## TUALATIN CITY PLANNING COMMISSION MEETING

THURSDAY, JANUARY 21, 2021

1. The Tualatin Planning Commission is asked to provide a recommendation to the City Council on adopting an updated Stormwater Master Plan for the City of Tualatin and updating Comprehensive Plan policies and relevant Development Code references to reflect the updated plan (Plan Text Amendment PTA 21-0001).

Exhibit 5 – Public Comments on Stormwater Master Plan 12-7-20 through 1-10-21

**Figure 7-1**  
**Capital Project Location Overview**

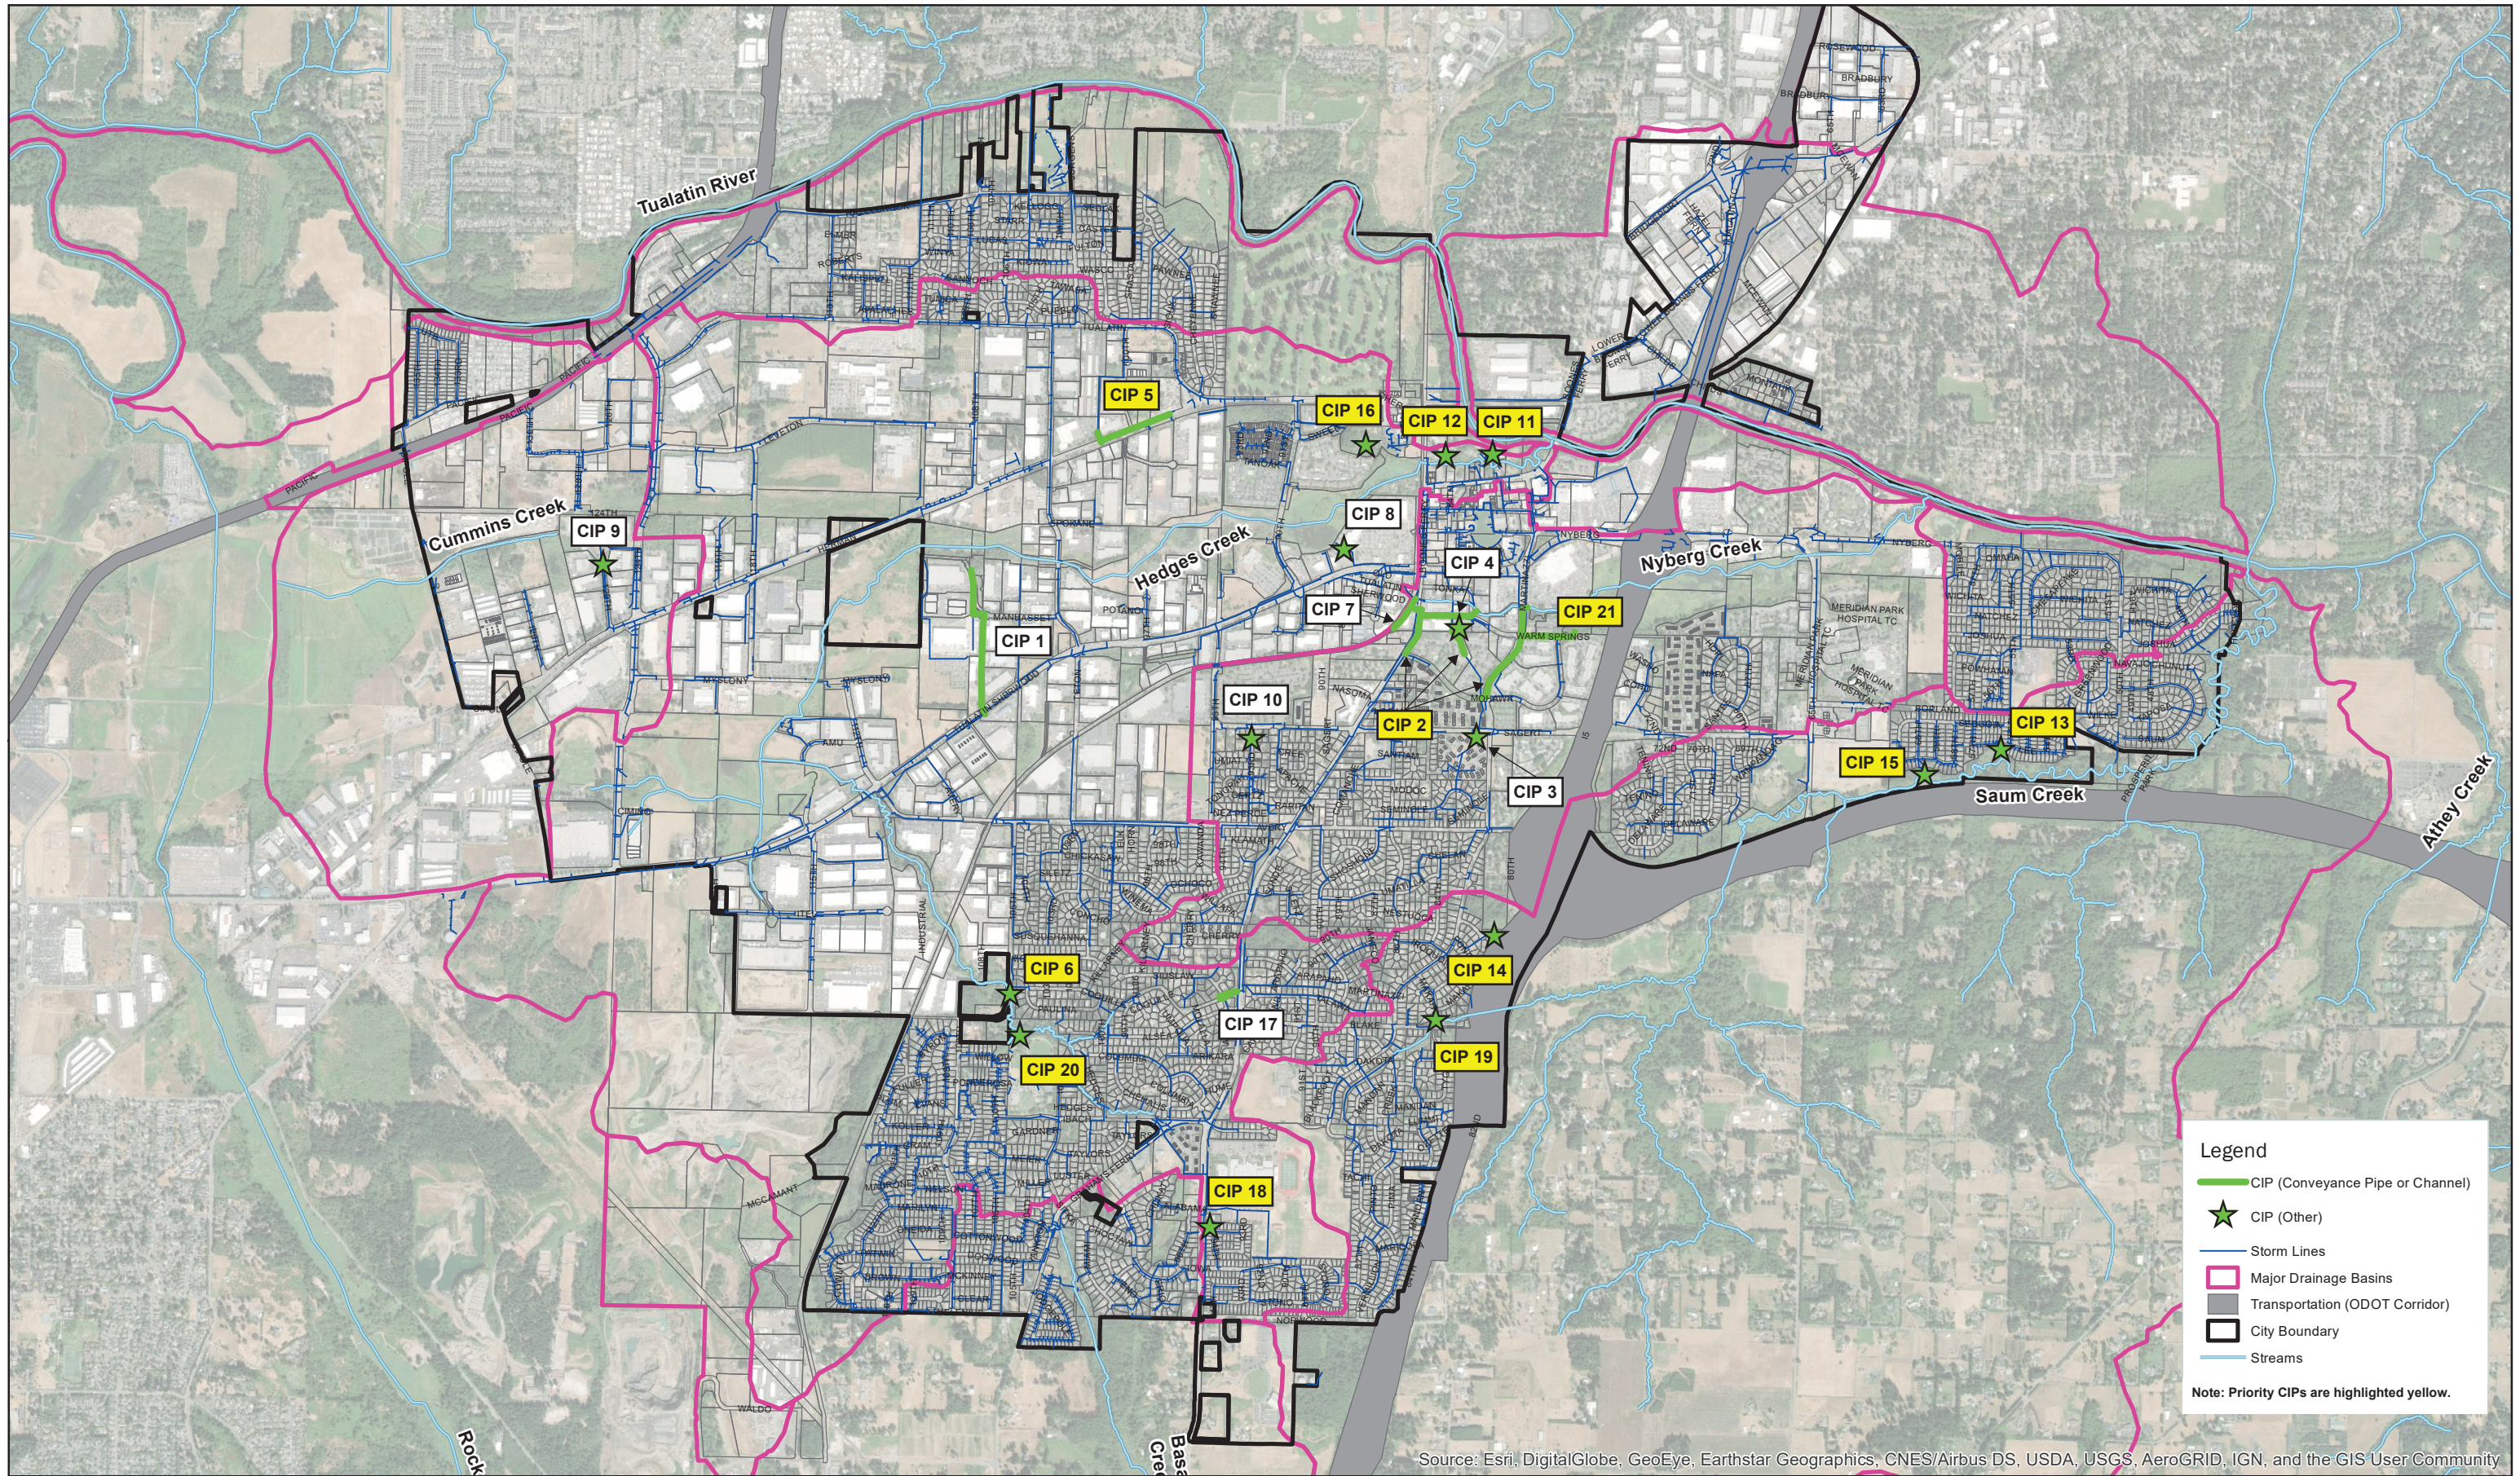
Comment LEA10. The BFR south area needs to exclude infiltration facilities as an alternative to reducing surface flow. Figure 7-1 (Page 3-2) does not show any CIP in the vicinity of BFR south although potential problems exist (see LEA Supplement B Part 2: Appendix A.2).

Comment LEA11. SWMP Figure 7-1 does show the location of CIP17, which is additionally described in Table 3-1 - City of Tualatin Stormwater Project Opportunities Number 6 as Alsea/BF Rd and 99th/Siuslaw Greenway. This CIP17 would drain to Hedges Creek and is comprised of "C" type soils as identified by Hydrologic Soil Group (see Section 2.4 -Soils, Table 3-1 and Figure 2-3). "C" type soils poorly drain and do not support functional infiltration facilities. The concern is that the "C" type soils above the Lucini property may be subjected to the same contradictory conclusion as the CIP17 site. This problem of misapplying design solutions may also exist for other conditions because BFR south has not been evaluated by Tualatin for hydrology and hydraulics as well as CIP.

**Figure 4.** Original County Subbasins - Erroneous Boundaries for Drainage above the Lucini Property.

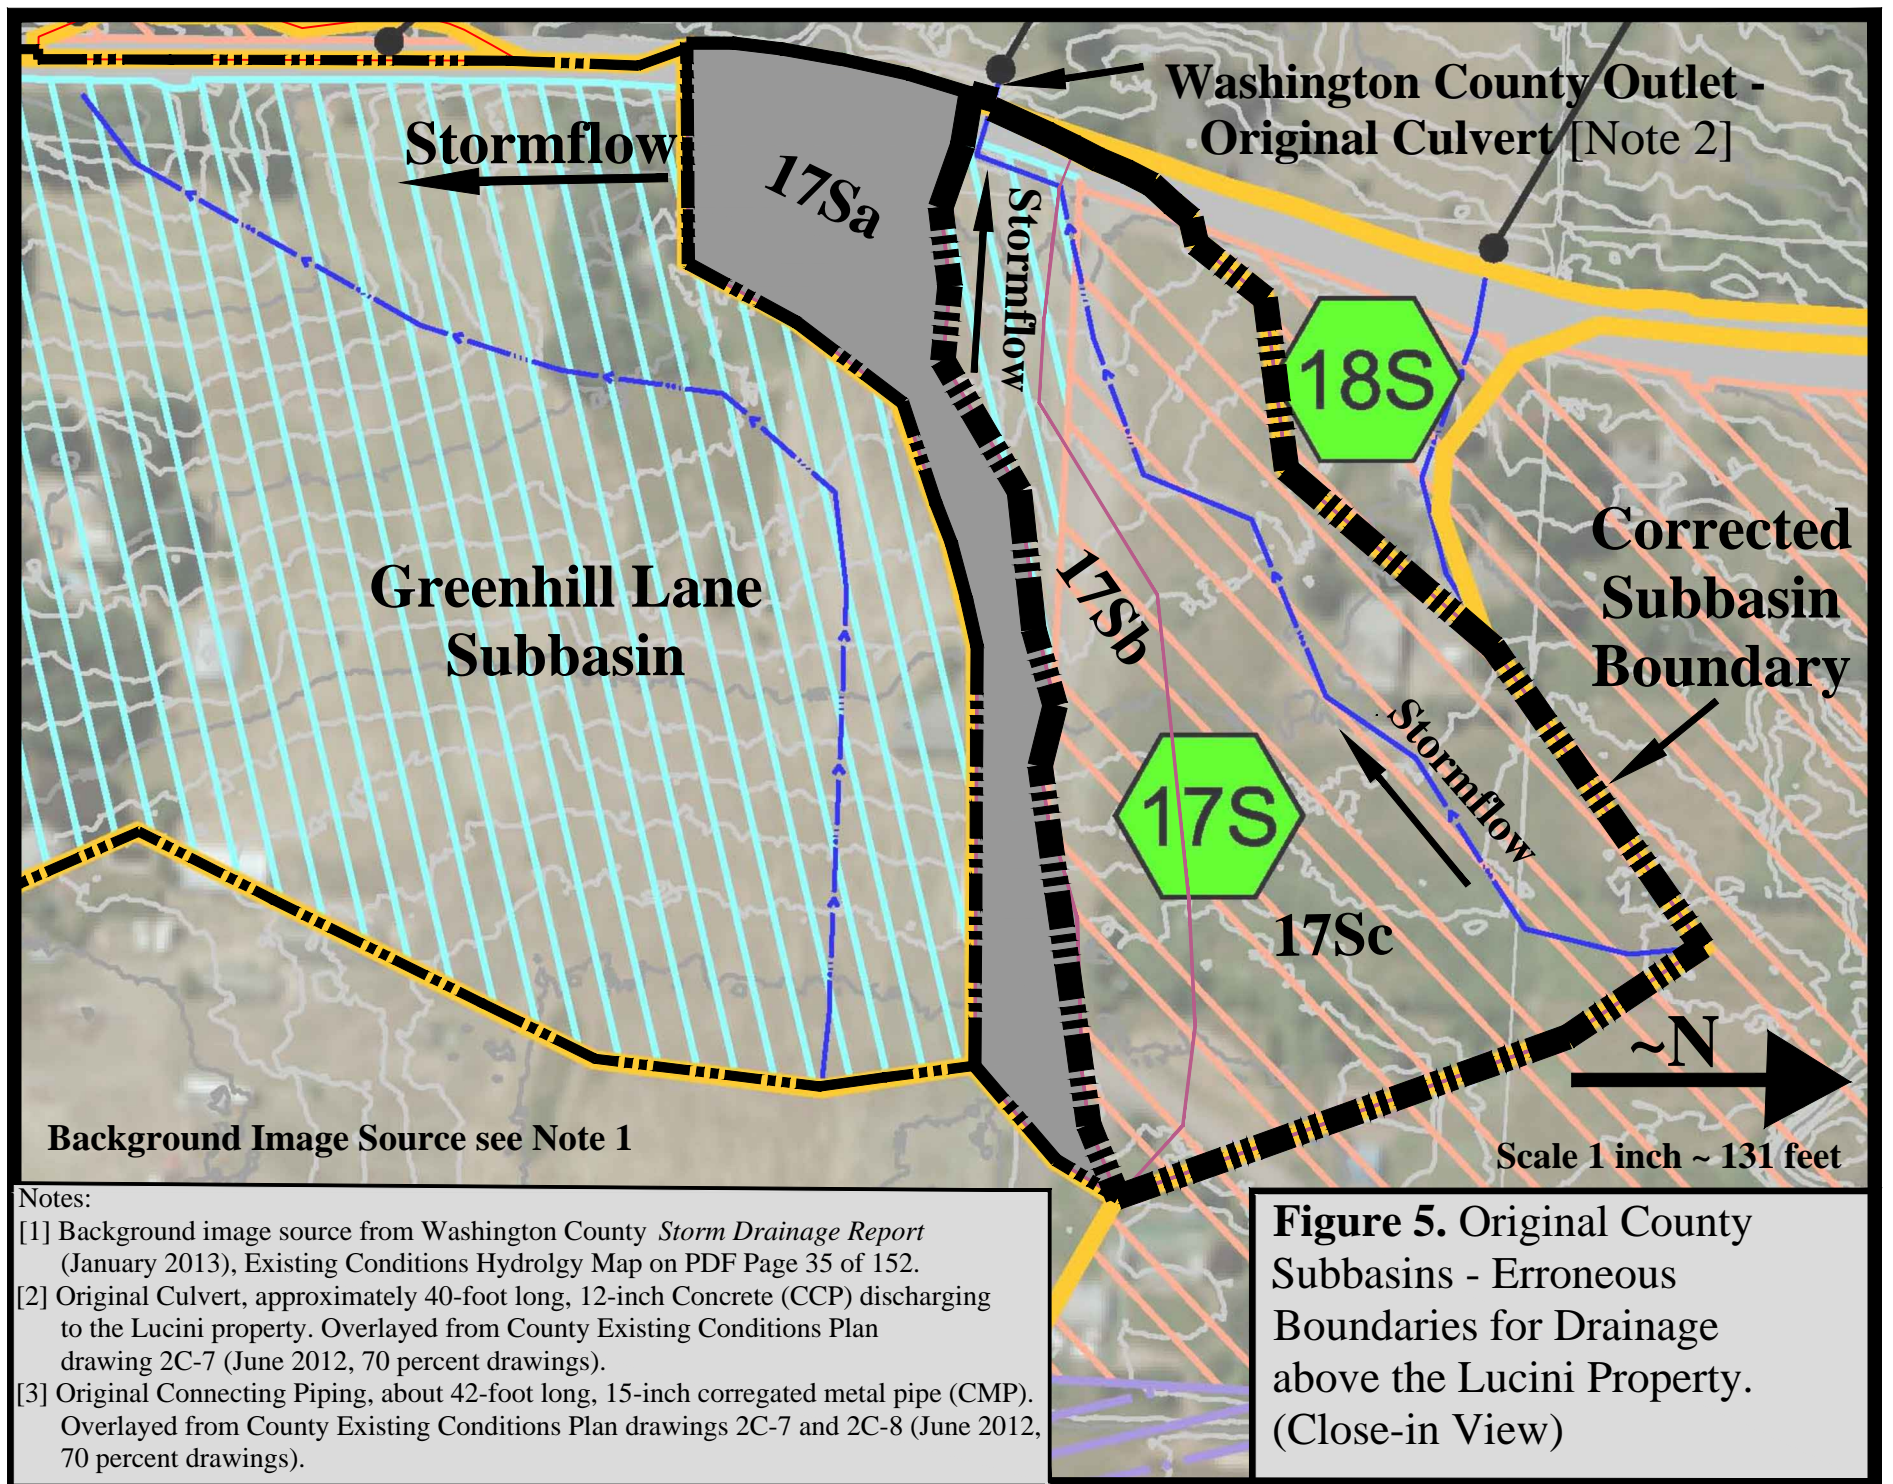
The hydrologic modeling considered a number of probable realistic cases unexamined in the Drainage Report for the 25-year design storm. The ORIGINAL subbasin configuration as depicted in Figure 4, which is corrected as shown in Figure 5. The hydrologic model was then run with the more accurate drainage area as the ORIGINAL subbasin configuration. This comparison demonstrates that the realistic (actual) peak flow value of 0.89 cubic-feet-second (cfs) discharging to the Lucini property is 31.5 percent less (see the Figure 6 column chart) than peak flow of 1.17 cfs claimed in the County's Drainage Report. This is critically important because the County is inflating the ORIGINAL stormflows and makes it seem like the ORIGINAL condition had higher flows. This is an adverse condition for the Lucini's because the Drainage Report analysis later claims to reduce the ORIGINAL stormflow amount that it previously inflated as part of the IMPLEMENTED project.

This resulted in erroneously concluding that the Boones Ferry Road right-of-way to the south of the original culvert<sup>13</sup> flowed into the Lucini property. The actual Original subbasin excluded all of the rainfall runoff from the southern strip of the County’s wrongly depicted subbasin. This condition is illustrated in Figure 5, which more accurately shows the ORIGINAL stormflow from the southern strip as being routed to the Greenhill Lane subbasin.<sup>14</sup>

**Figure 9.** IMPLEMENTED County Subbasins - Erroneous Boundaries for Drainage above the Lucini Property.

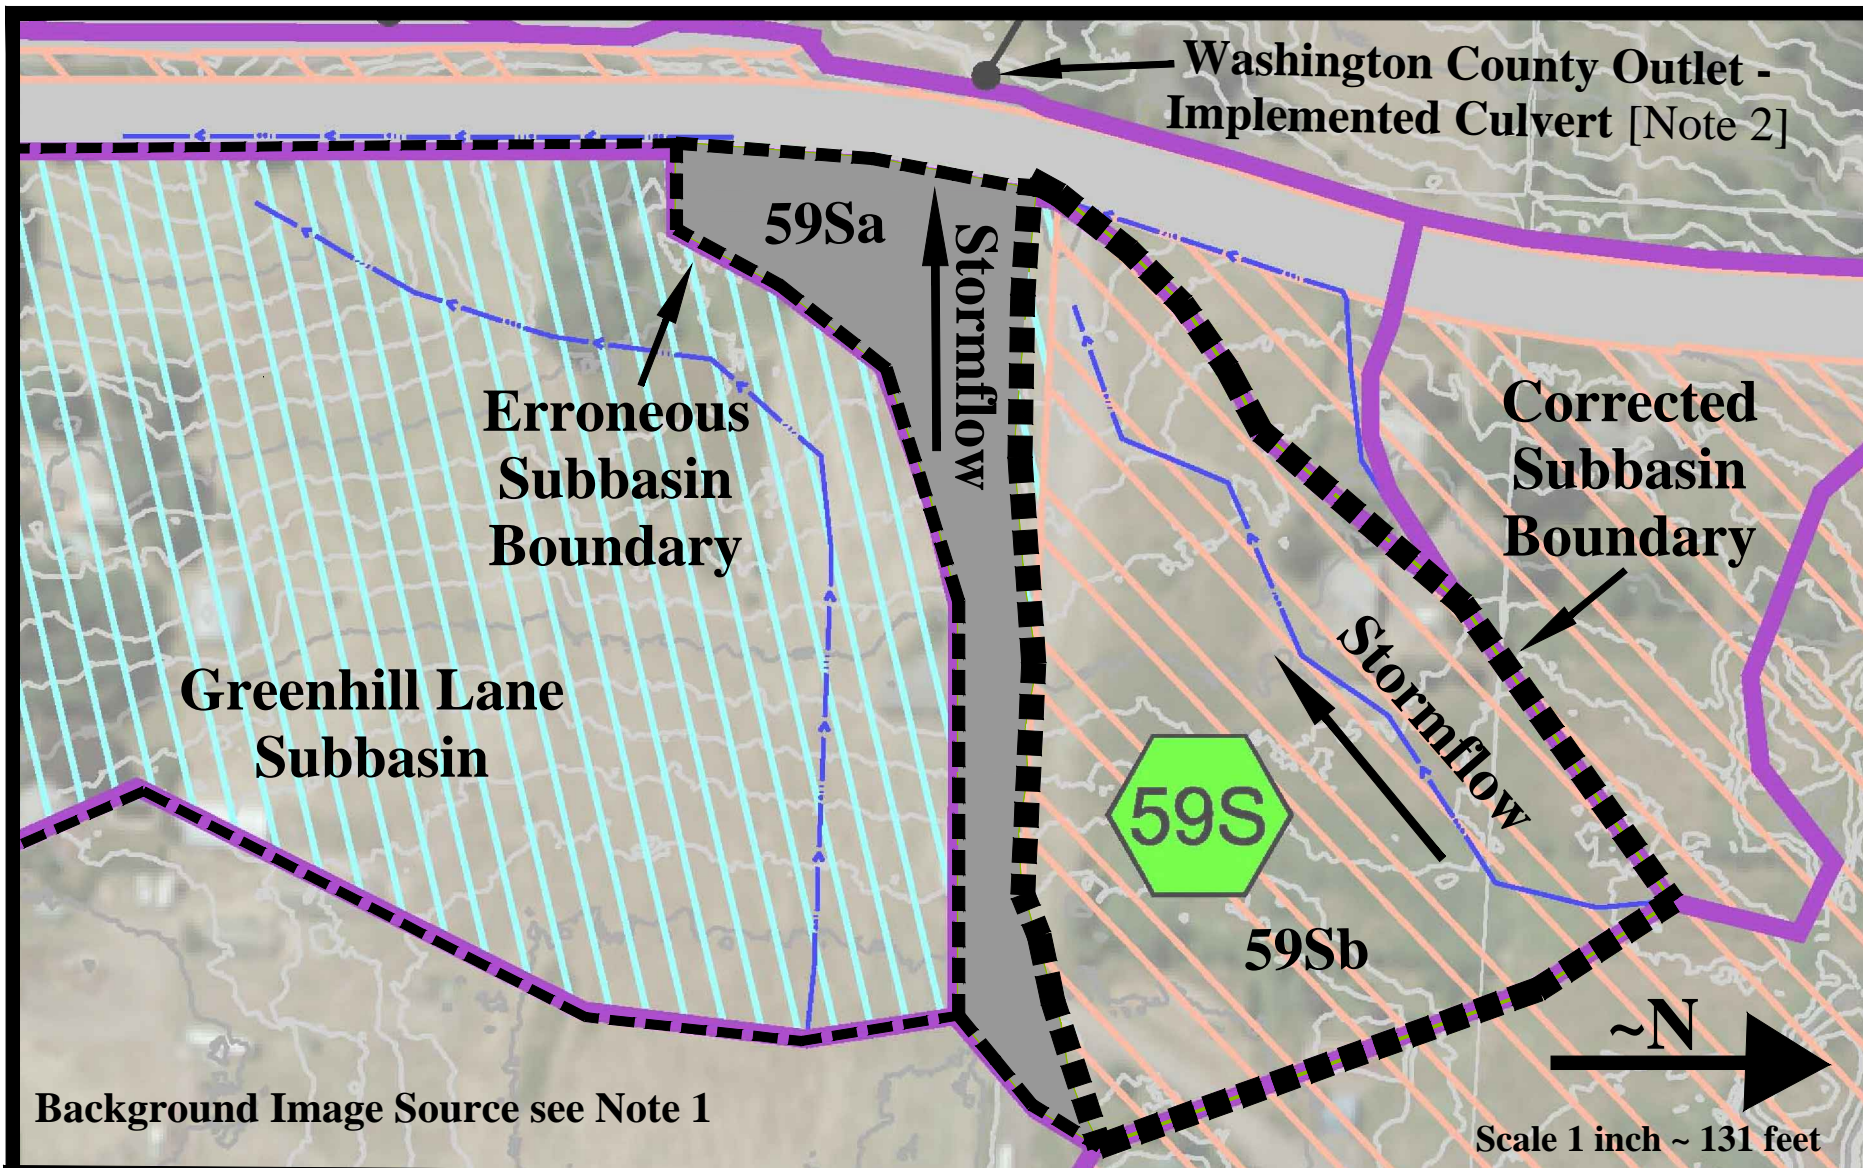
Stormflow values are graphically compared in the Figure 6 through Figure 8 column charts. Figures 9 and 10 show the subbasin boundaries for IMPLEMENTED conditions, which permanently re-rout stormflows from a portion of the Greenhill Lane subbasin ultimately onto the Lucini property
